Re: NH SEC Docket No. 2015-04: Public Service Company of New Hampshire d/b/a Eversource Energy (“PSNH” or the “Applicant”) for a New 115 kV Transmission Line from Madbury Substation to Portsmouth Substation.

NH PUC Docket DE 16-441, DE 16-442: Revisions to PSNH’s Petitions for Licenses to Construct and Maintain Electric Lines, Neutral Wire and Fiber Optic Cable Over and Across Public Waters and Public Lands of New Hampshire

Revisions to the
NHPUC Public Water and Public Land Crossing
License Applications

SUMMARY
Revisions between Originally Submitted Petition
And Revised Engineering Design

EVERSOURCE ENERGY	TRANSMISSION BUSINESS		9
			T
F107 LINE CROSSING LITTLE BAY			
DURHAM AND NEWINGTON, NEW HAMPSHIRE			
DRAWN	SCALE AS NOTED	DATE 4/15/15	SHEET 1 OF 1
ENGINEER	DRAWING NO. F10740905		
CHECKED			
APPROVED

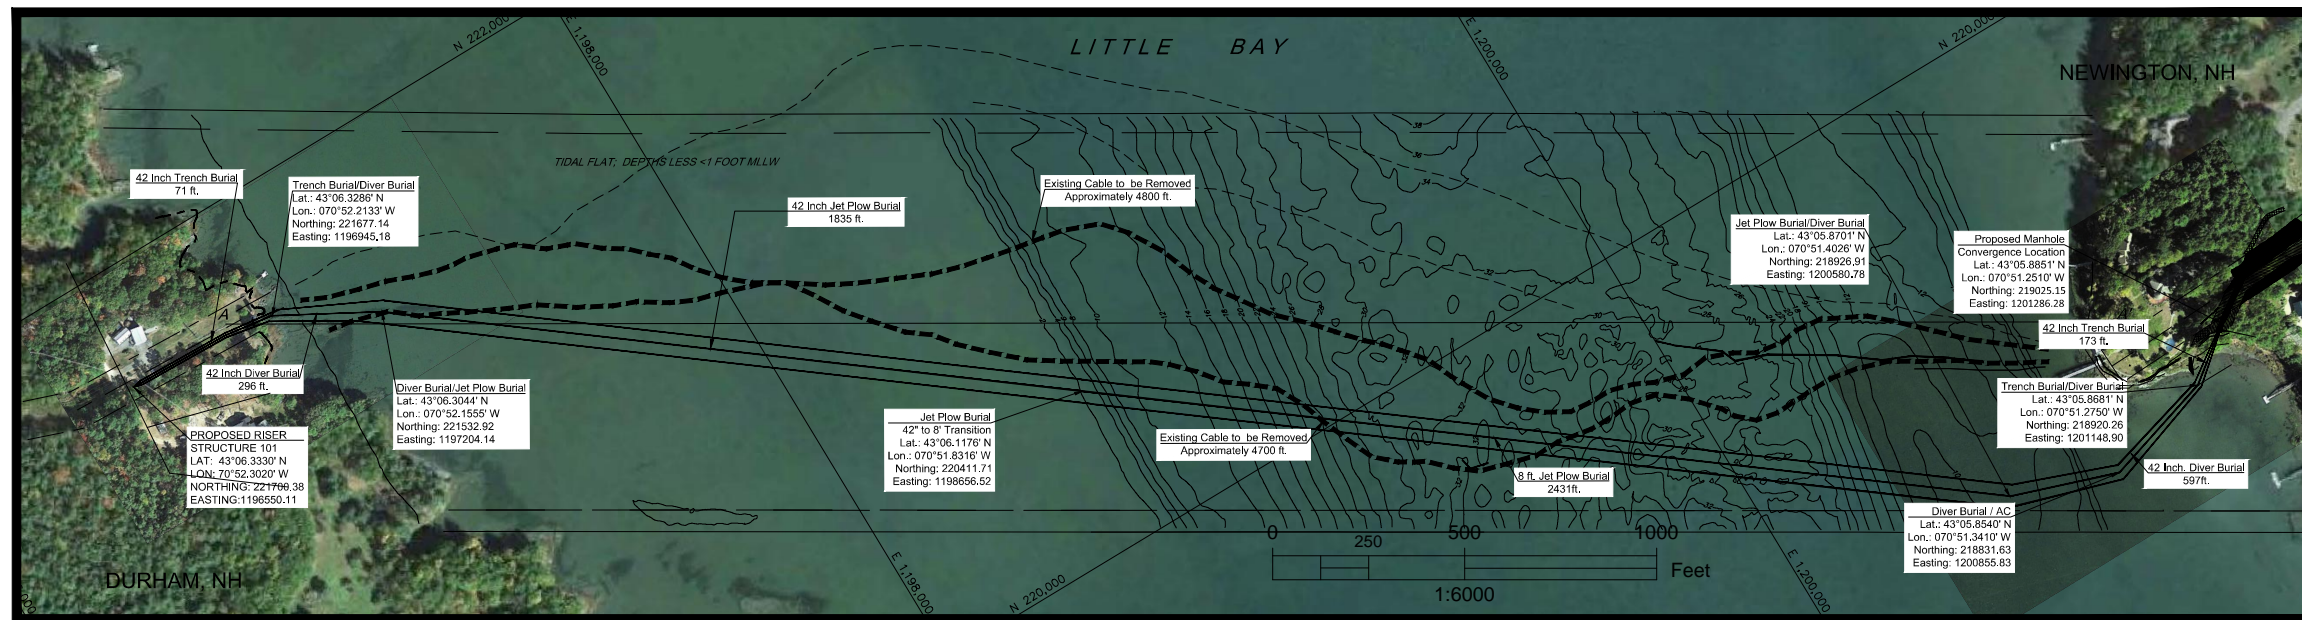
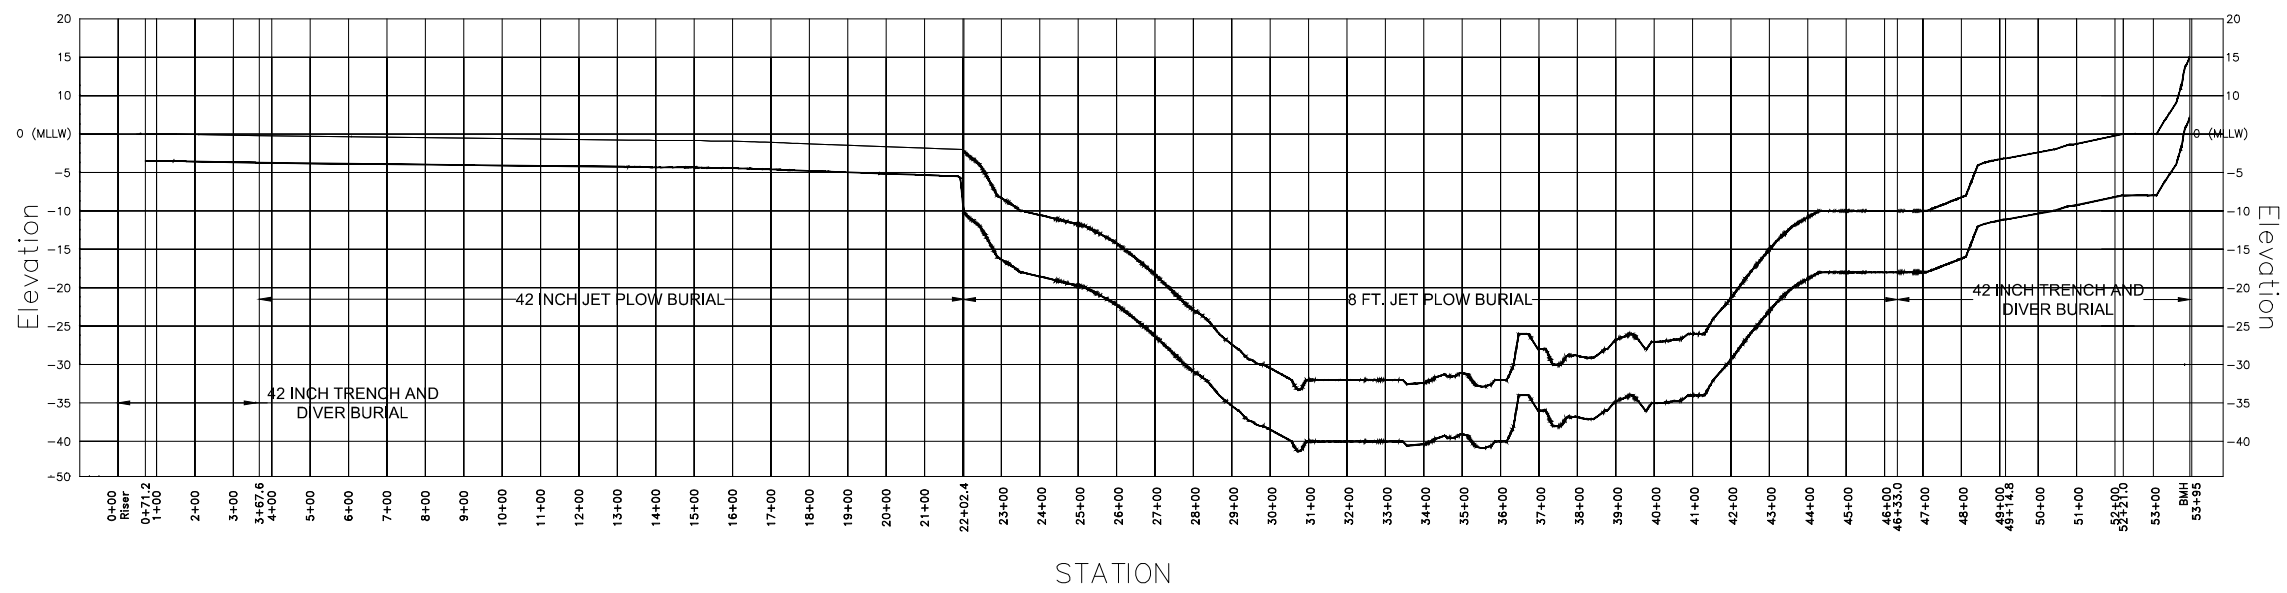
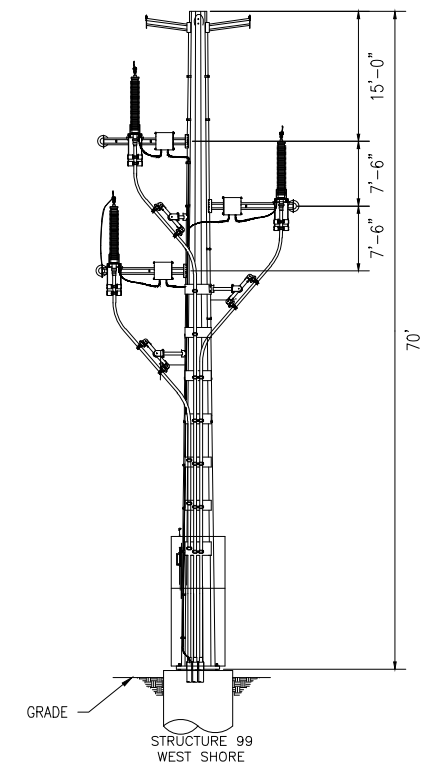
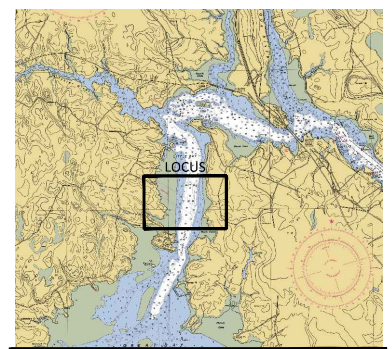
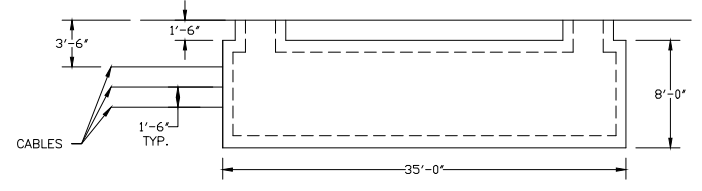
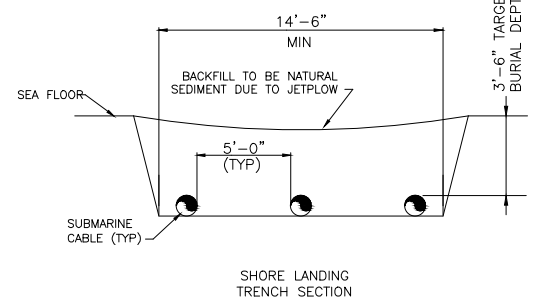
1. Paragraph #1- Revised Drawing number F10740905 (Exhibit 7) has been supplied.
2. Paragraph #1- **Change** "PSNH" to "Eversource Energy"
3. Paragraph #3- **Change** "80 feet" to "70 feet"
4. Paragraph #3- **Change** "6 to 12 feet" to "7.5 to 15 feet"
5. Paragraph #3- **Clarification**- Davit arms on steel structure are approximately 10 feet long.

SEACOAST RELIABILITY PROJECT
 STRUCTURES #46-56
 STATE OF NH PROPERTY CROSSING

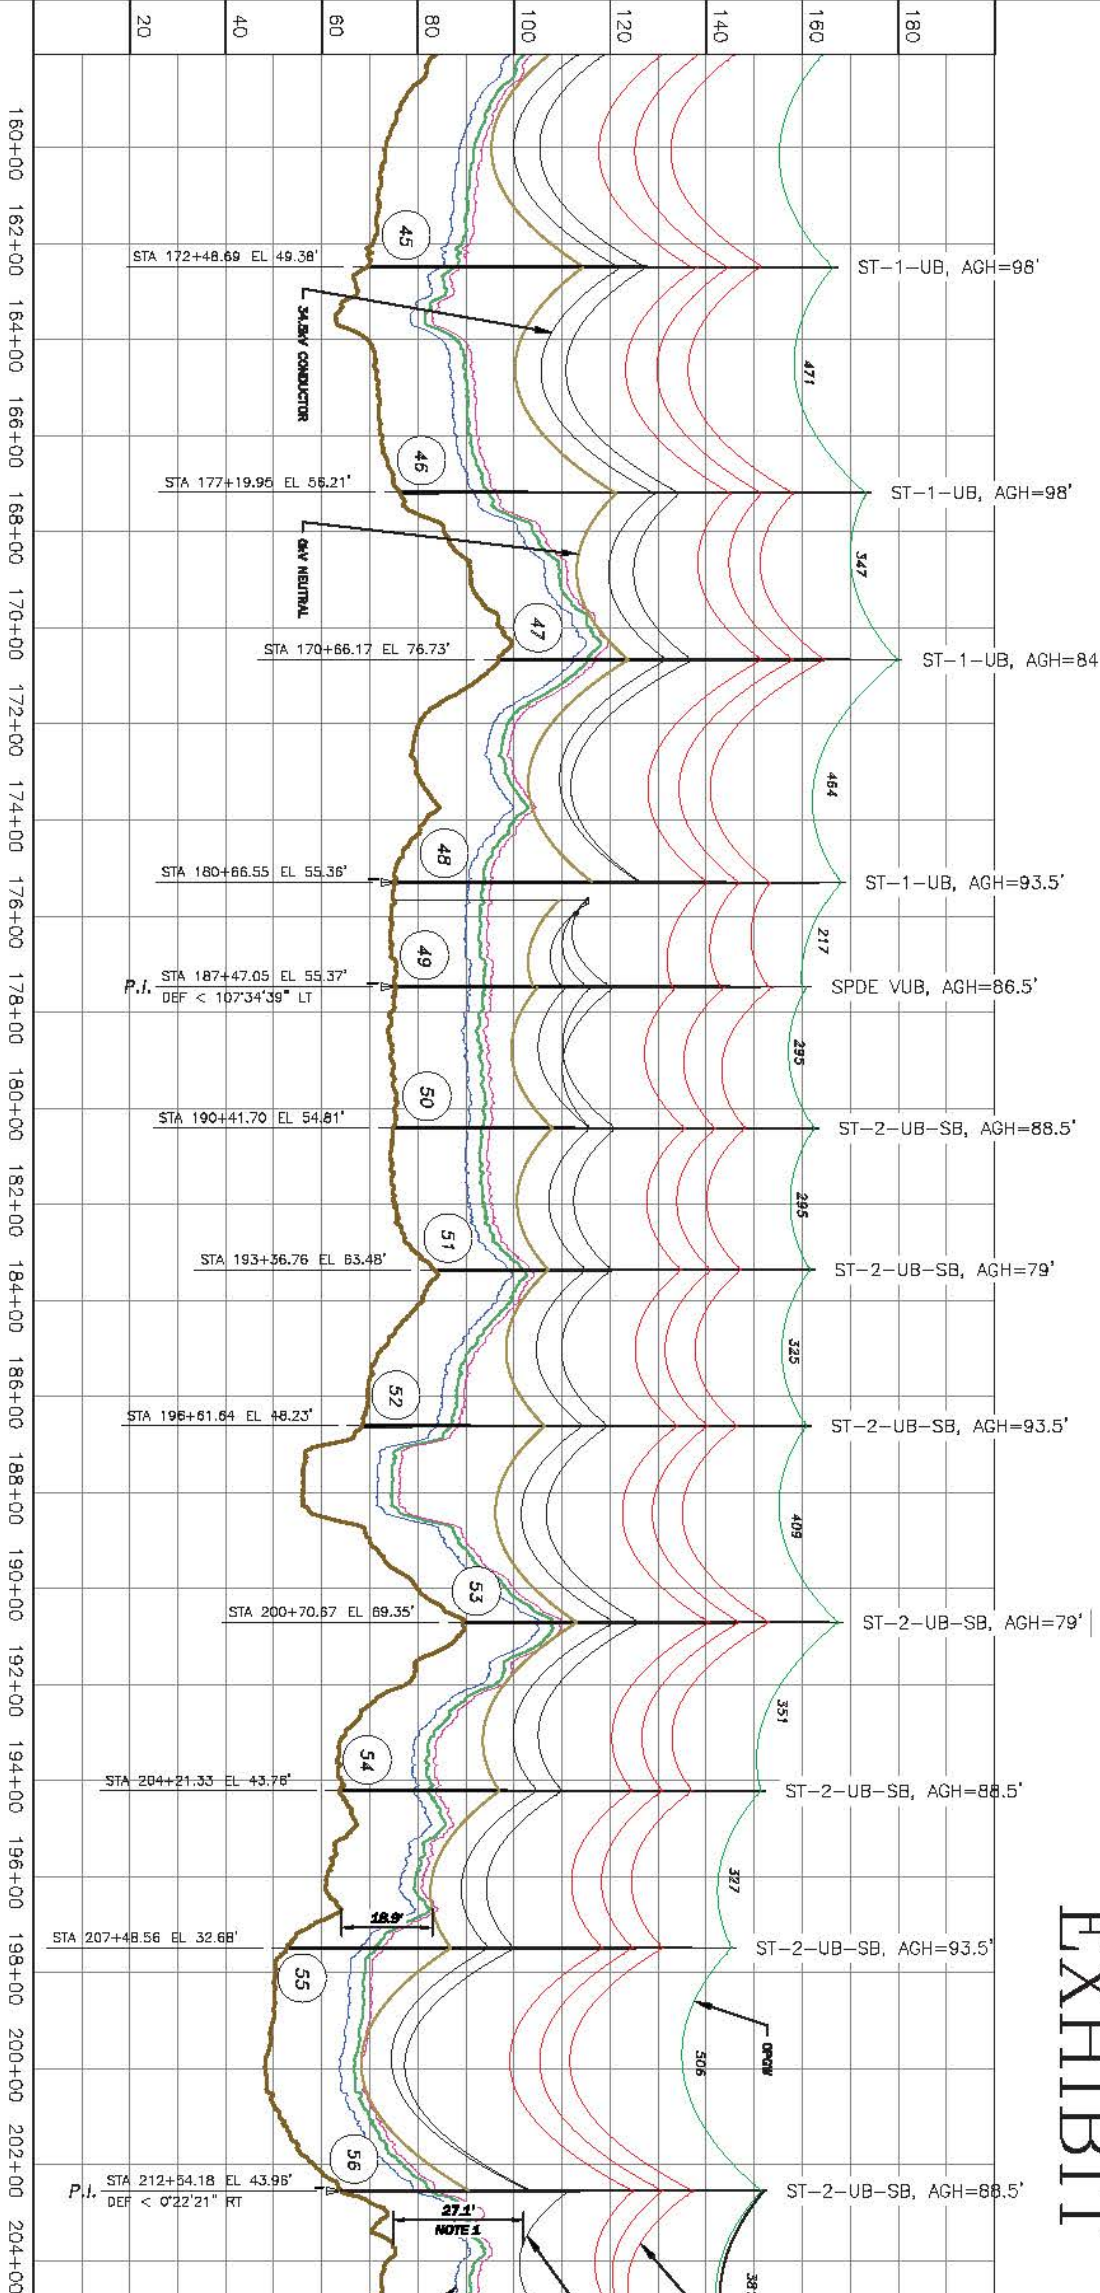
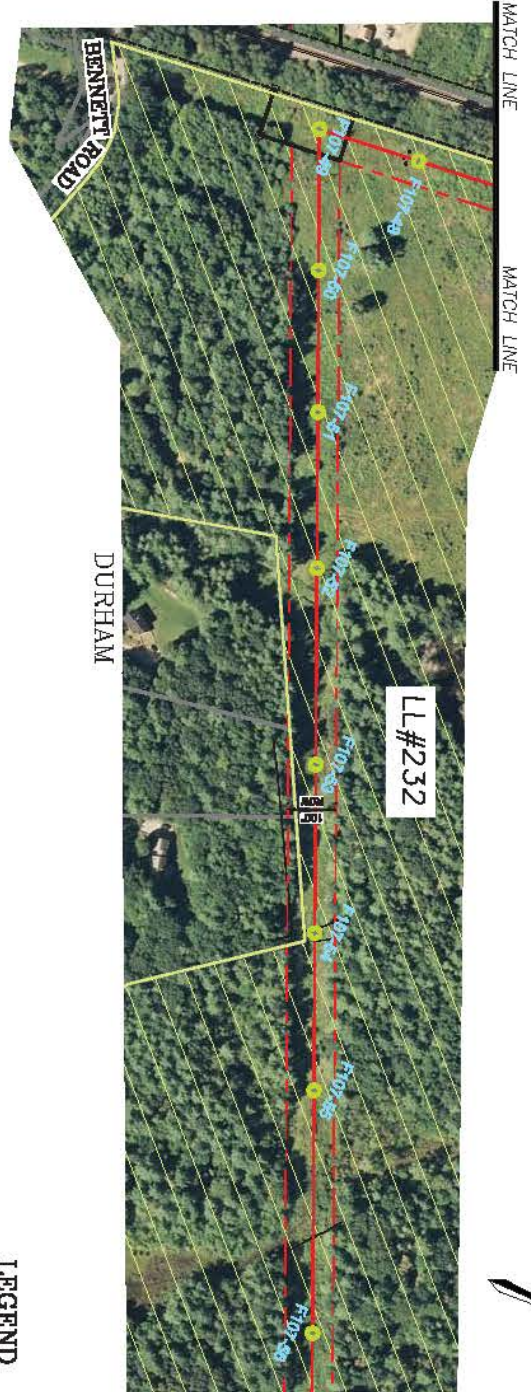
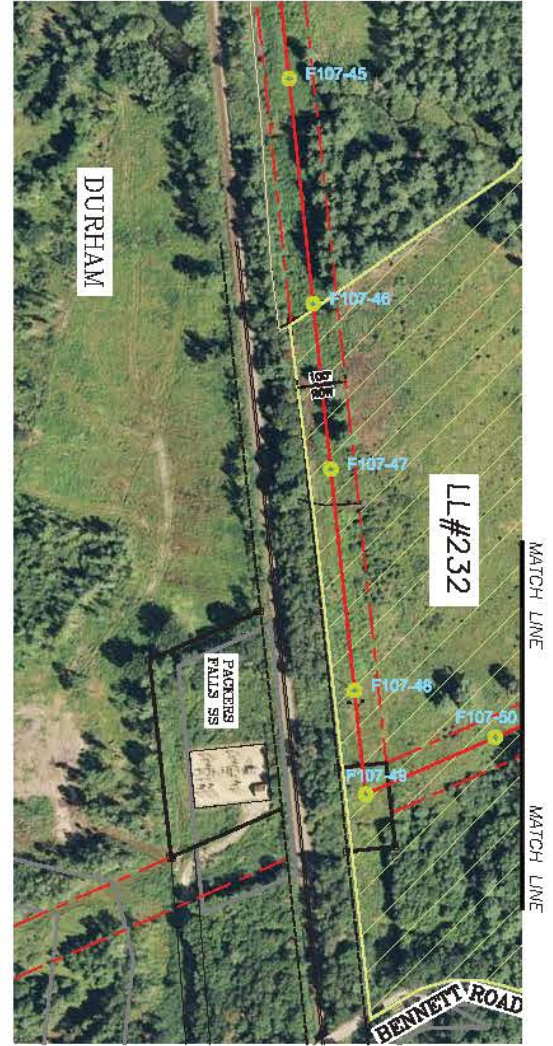
1. Paragraph #1- Revised Drawing number F10799002 (Exhibits 2 and 3) has been supplied. No changes to location plan (Exhibit 1).
2. Paragraph #3- **Change** “WT-1-UB,” “WT-2-UB” and “RAX-UB” to “ST-1-UB”, “ST-2-UB” and “SRAX-UB” respectively.
3. Paragraph #3 Bullet 1- **Change** “7.5-15 feet” to “7.5-13 feet”
4. Paragraph #3 Bullet 1- **Change** “nine inches” to “six inches”
5. Paragraph #3 Bullet 1- **Change** “7.5 feet” to “7.0 feet”
6. Paragraph #3 Bullet 2- **Change** “7.5-15.5 feet” to “7.5-12.5 feet”
7. Paragraph #3 Bullet 2- **Change** “nine inches” to “six inches”
8. Paragraph #3 Bullet 2- **Change** “0-2.5 feet” to “0-5 feet”
9. Paragraph #3 Bullet 3- **Change** “nine inches” to “six inches”

10. Paragraph #3 Bullet 3- **Change** “15 feet” to “11.75 feet”

11. Table 1 Column 3- **Change** 15.5 feet to 18 feet

12. Paragraph #5- **Change** “water” to “land”

13. **Replace** Table 3 with revised table below

Structure (Back)	Height (Ft)	Structure (Ahead)	Height (ft)	Span (ft)	Clearance At 285°F (ft)
46	98	47	84	347	46.4
47	84	48	93.5	464	46.1
48	93.5	49	86.5	217	56
49	86.5	50	88.5	295	52.7
50	88.5	51	79	295	51.5
51	79	52	93.5	325	48.6
52	93.5	53	79	409	50.1
53	79	54	88.5	351	47.5
54	88.5	55	93.5	327	49.2
55	93.5	56	88.5	506	50.9
56	88.5	57	74.5	381	41.1
57	74.5	58	65.5	634	40.4

Structure (Back)	Height (Ft)	Structure (Ahead)	Height (ft)	Span (ft)	Clearance At 212°F (ft)
46	98	47	84	347	26.2
47	84	48	93.5	464	26.7
48	93.5	49	86.5	217	32.1
49	86.5	50	88.5	295	30.3
50	88.5	51	79	295	31.5
51	79	52	93.5	325	26.9
52	93.5	53	79	409	30.1
53	79	54	88.5	351	25.9
54	88.5	55	93.5	327	26.6
55	93.5	56	88.5	506	25.8
56	88.5	57	74.5	381	21.6
57	74.5	58	65.5	634	24.9

Structure (Back)	Height (Ft)	Structure (Ahead)	Height (ft)	Span (ft)	Clearance At 120°F (ft)
46	98	47	84	347	19.15
47	84	48	93.5	464	19.35
48	93.5	49	86.5	217	27.4
49	86.5	50	88.5	295	25.1
50	88.5	51	79	295	24.9
51	79	52	93.5	325	20.7
52	93.5	53	79	409	23.5
53	79	54	88.5	351	19.7
54	88.5	55	93.5	327	18.9
55	93.5	56	88.5	506	19.4
56	88.5	57	74.5	381	23.6
57	74.5	58	65.5	634	26.9
